February 13, 2014

RE: Packer Setting Depth Exception

Injection Authority: Administrative Order SWD-326
Pool: SWD; Seven Rivers formation
D & E Federal Well No. 1 API 30-025-02448
Unit N, Sec 22, T20S, R34E, NMPM, Lea County, New Mexico

INJECTION WELL DATA SHEET

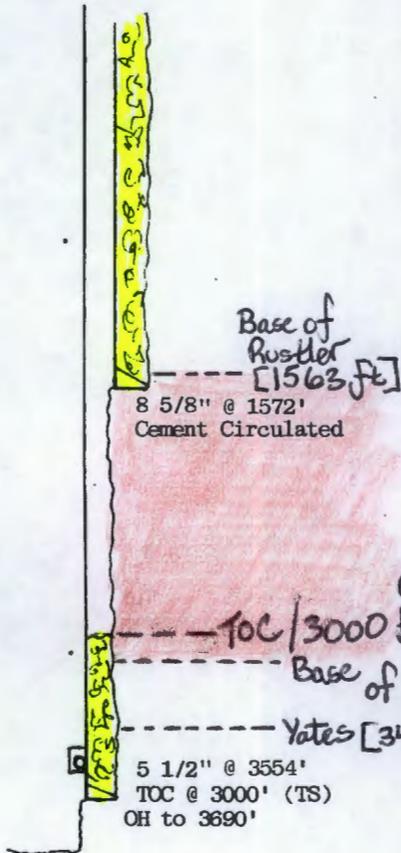
It is our understanding that during the completion of a mechanical integrity testing conducted in January on this well that the packer set was determined to be at a depth of 3308 feet. The packer was installed at this location in order to achieve proper seating of the packer set. This location of the packer is approximately 170 feet above the top of the perforated injection interval that begins at 3478 feet. Administrative Order SWD-326 approved July 20, 1987, authorized injection through perforations from 3478 feet to 3496 feet and through open hole from 3533 feet to 3690 feet.

- 1) PPC Operating Company LLC
Rhodes Yates Unit # 10
30-025-12058
UL-L, Sec 27, T26S, R37E
Reports packer at 2963' w/ top perforation at 3122'. Well tested good.
- 2) Chestnut Exploration and Production Inc.
D and E Federal # 1
30-025-02448
UL-N, Sec 22, T20S, R34E
Reports packer at 3308 w/ top perforation at 3533'. Well tested good.

$$\begin{array}{r} 3375 \\ - 3308 \\ \hline + 67 \text{ ft} \end{array} \qquad \begin{array}{r} 3478 \\ - 3308 \\ \hline + 170 \end{array}$$

For the reasons stated in the application and because it appears that correlative rights are protected, waste will not occur and this modification will not endanger any fresh water aquifer or the environment, the exception is granted. The packer location within this well shall not be set higher than 170 feet unless the operator receives written approval from the Division Director.
